Contract No. C24W08
Airport Tung Chung Link
Submission of Updated Construction Noise Management Plan (CNMP)

**Contract C24C03 – Independent Environmental Checker Consultancy Services for
Airport Tung Chung Link
Construction Noise Management Plan (Ref: RT25358-AC-01E)**

Document Title: Construction Noise Management Plan

CONSTRUCTION NOISE MANAGEMENT PLAN

Extracted from Appendix 3.7 of the Approved EIA of Tung Chung Line Extension (AEIAR-235/2022)

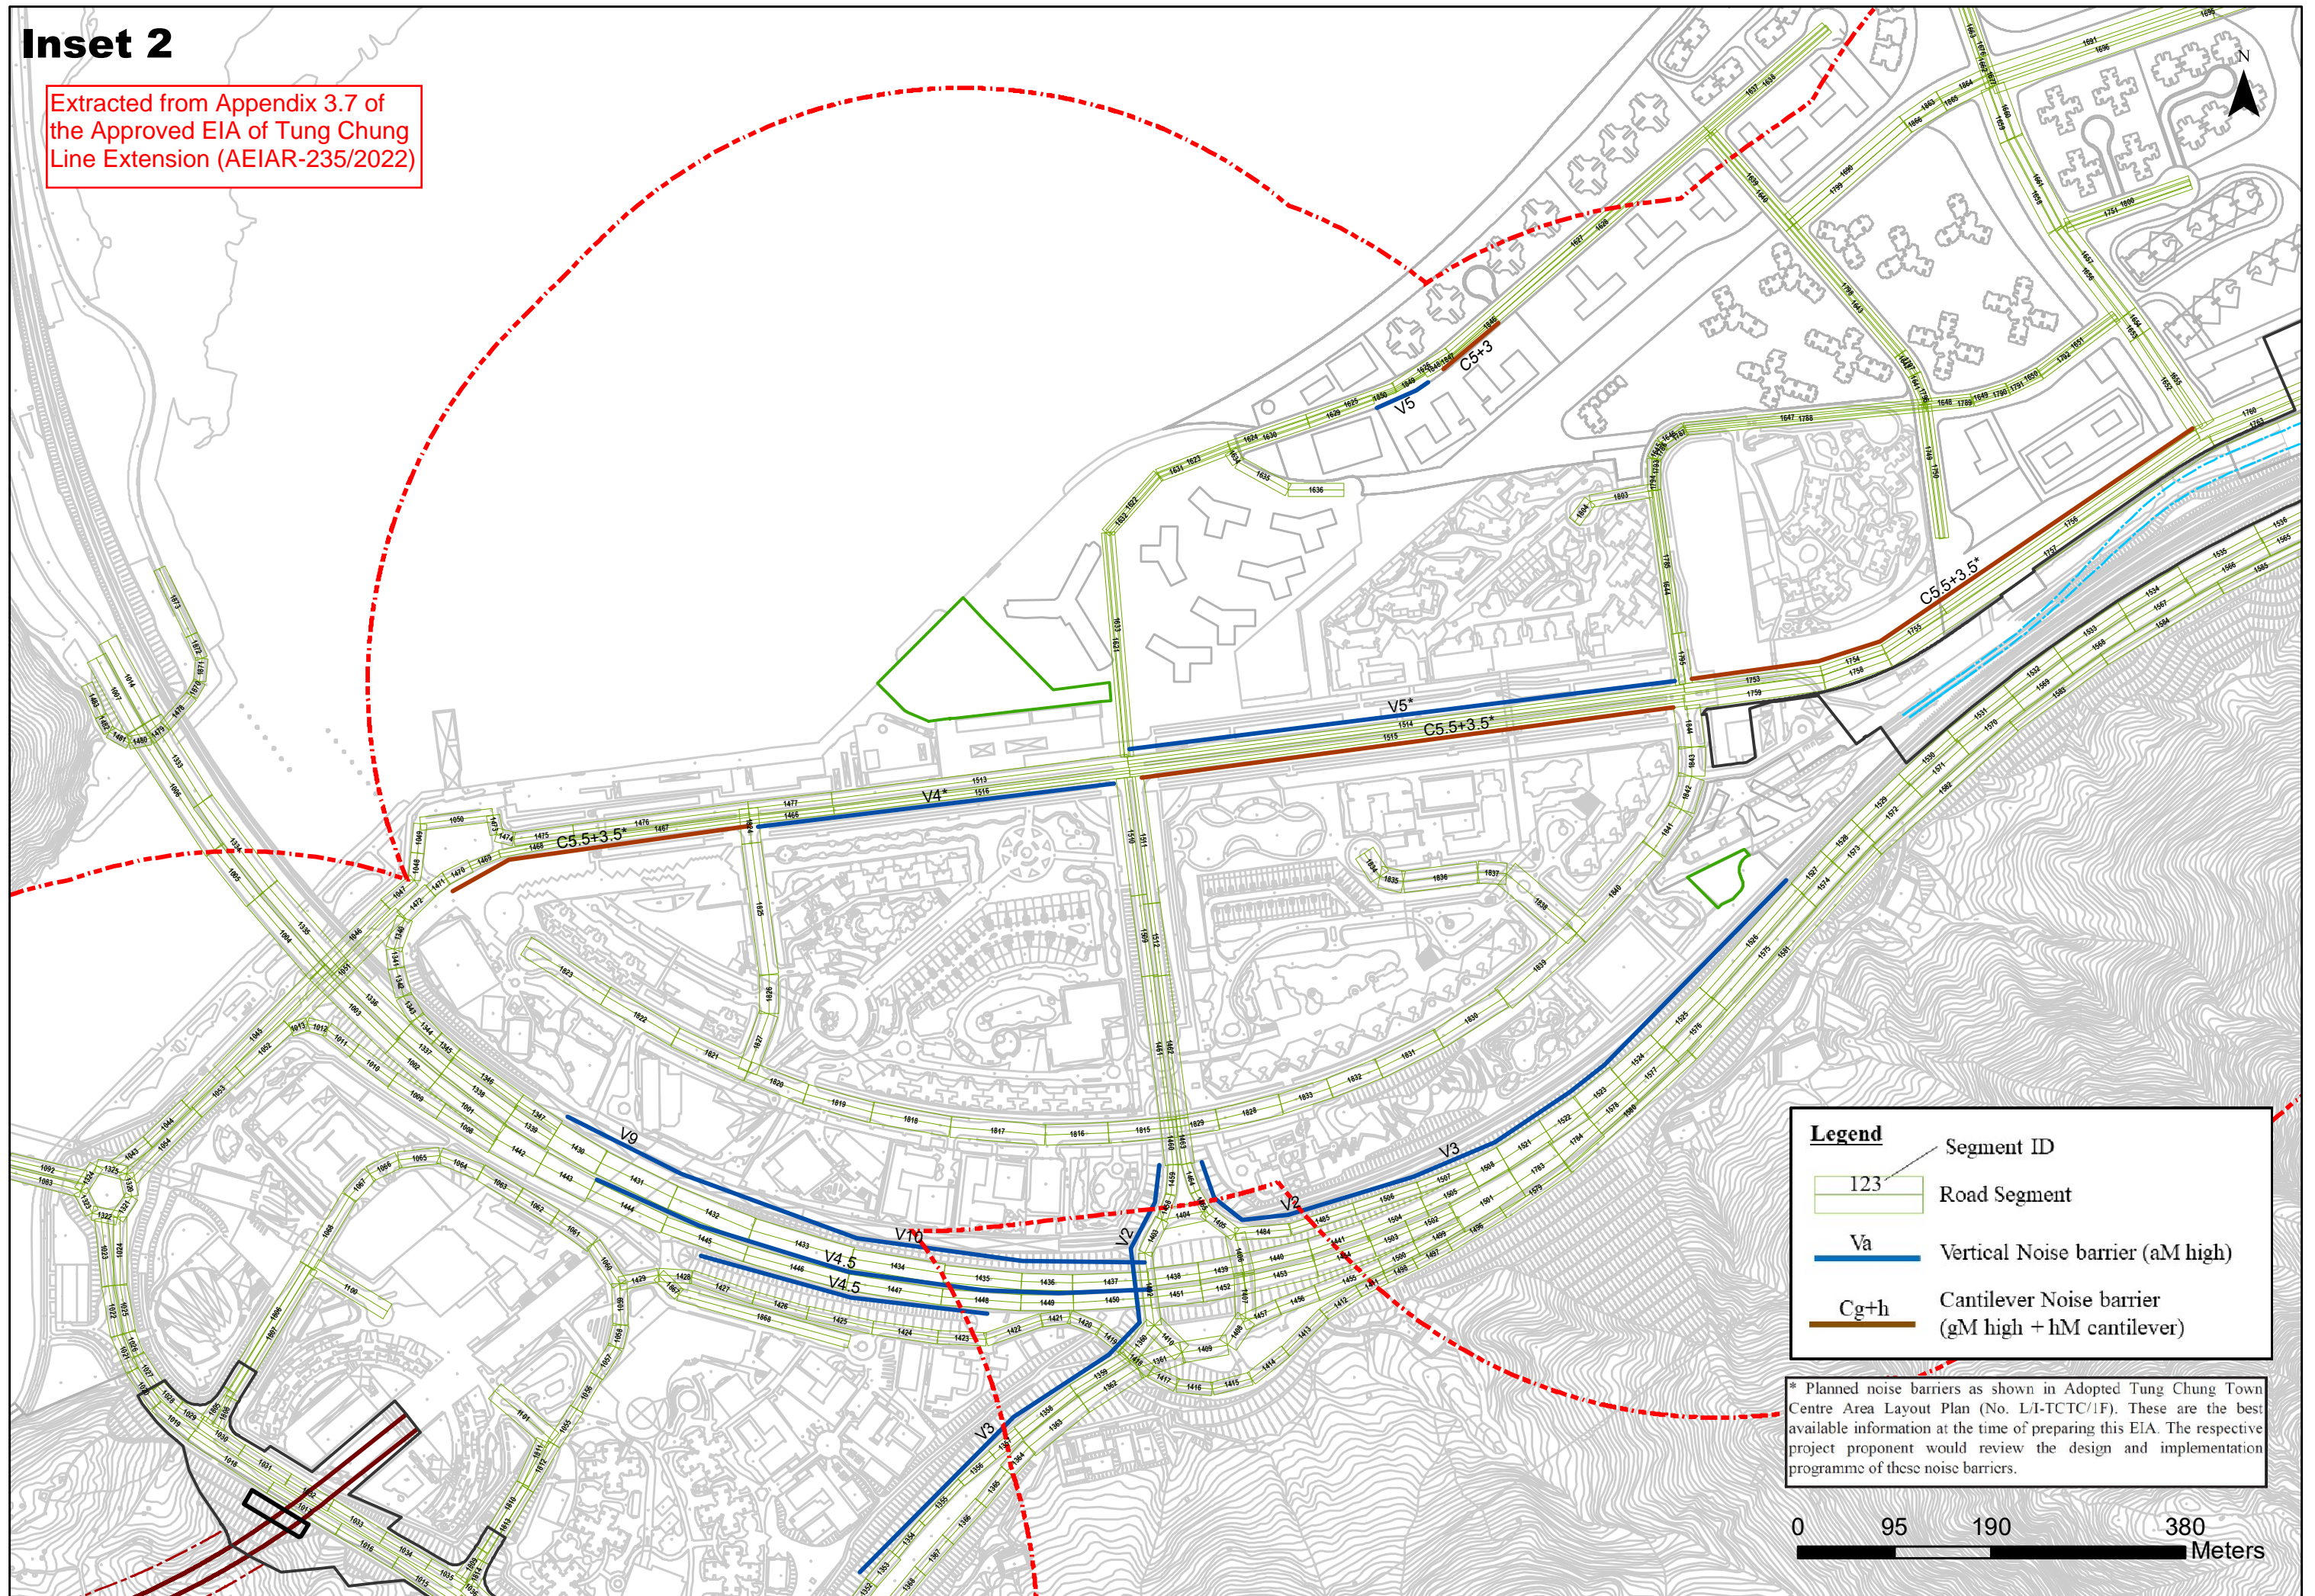
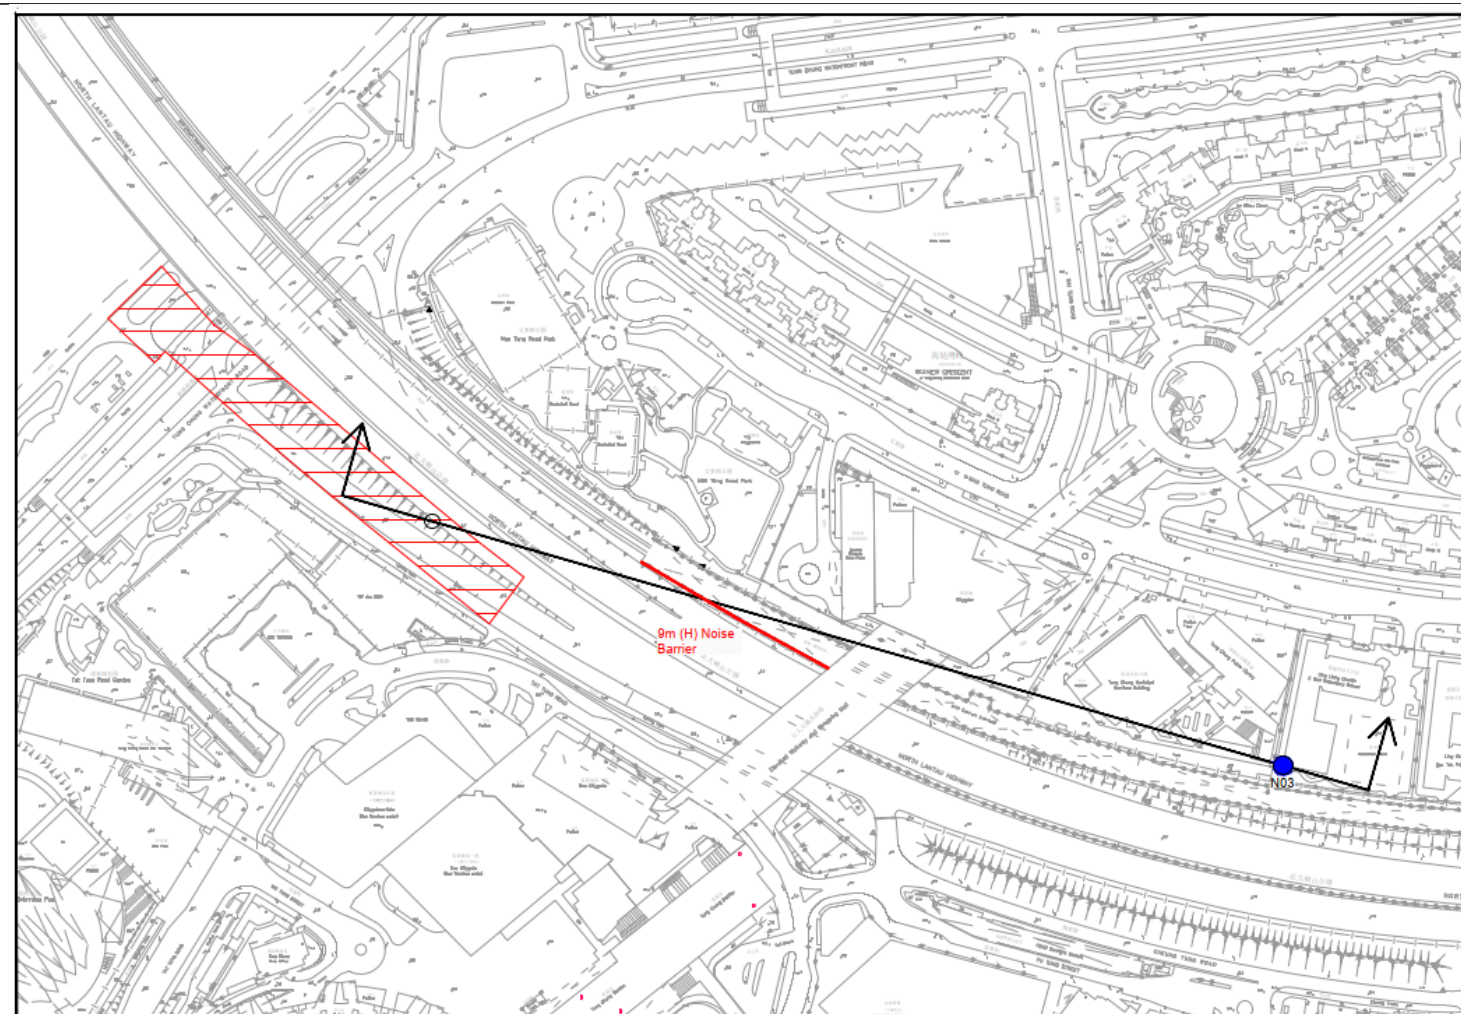
Section	Comments	Responses
1.	Appendix C – Note 3	Please check the source of the height of the barrier. The stated Appendix 3.7 of Approved EIA of Tung Chung Line Extension is “Hourly Composite Vehicular Emission Factor”.	The referenced EIA is currently considered the best available information on the height of the barrier.

Section Drawing of Site B to N03

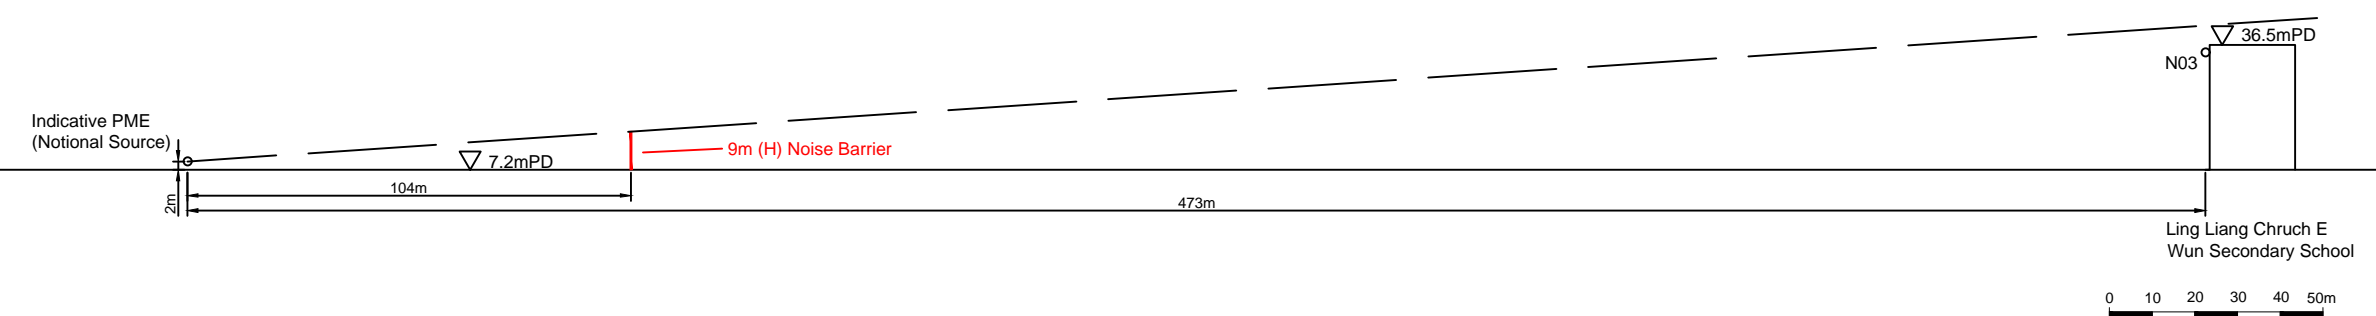
4.	Appendix D	Refer to NCO TM on noise from construction works other than percussive piling, “In cases where the Authority considers that all items of PME to be used on the construction site will be totally screened by a substantial barrier such that none will be visible when viewed from any window, door or other opening in any facade of the NSR, a negative correction of 10 dB(A) shall be applied to the PNL obtained in Step 9.” In Appendix D, the drawings only demonstrate the barrier can screen the PME at notional location. Please review if the existing noise barrier / structure can fully screen the whole site area such that 10dB reduction can be justified. If not, please consider deploying barriers at the location not screened by existing noise barrier / structure.	-5 dB(A) has been adopted for at N03 for Site B.

8.	Appendix D	Please review if Work Area Site B can be totally screened by the stated noise barrier, especially the portion near the Tung Chung waterfront road.	-5 dB(A) has been adopted for at N03 for Site B.

Section Drawing of Site B to N09

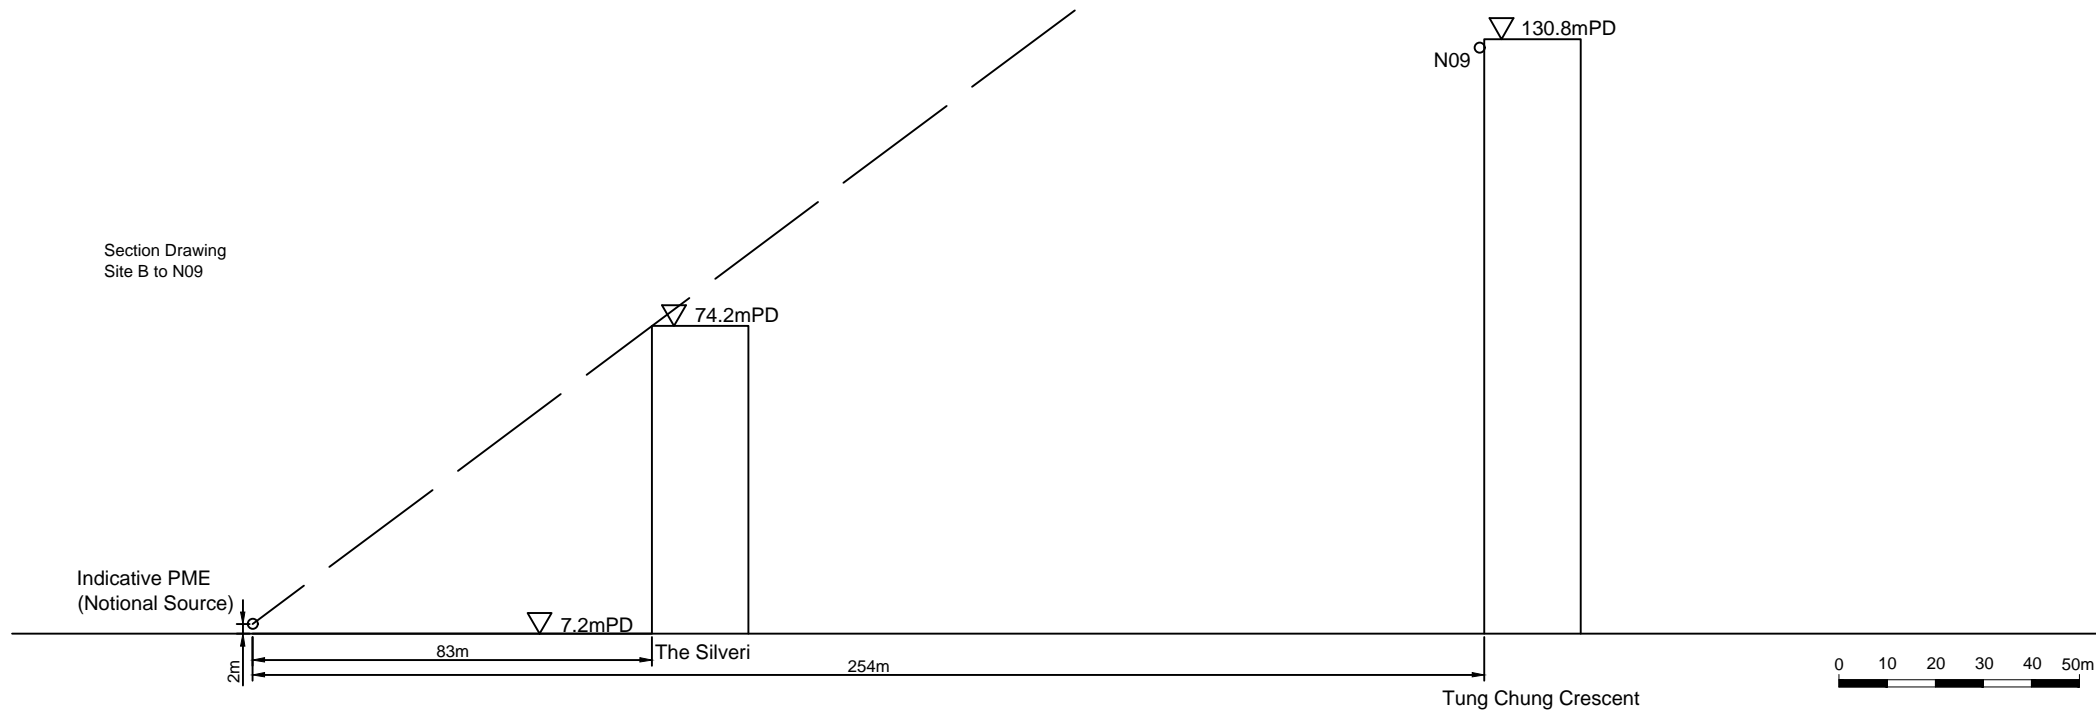
2.	Appendix C – Note 3	Last sentence – Please check if “site A” should be revise as “site A and B”.	Revised accordingly.
3.	Appendix D	Please indicate the source of the first drawings.	The source of the drawing reference to harrier of barrier has been added.

5.	Appendix D	Drawings for N05 and N06 are not found. Please review.	As mentioned in the revised notes in Appendix C, since there are existing buildings located in front of N05 and N06, and that the building height of these existing buildings are higher than N5 and N06, the direct line-of-sight at N05 and N06 are confirmed to be blocked. Section drawings are considered not necessary.
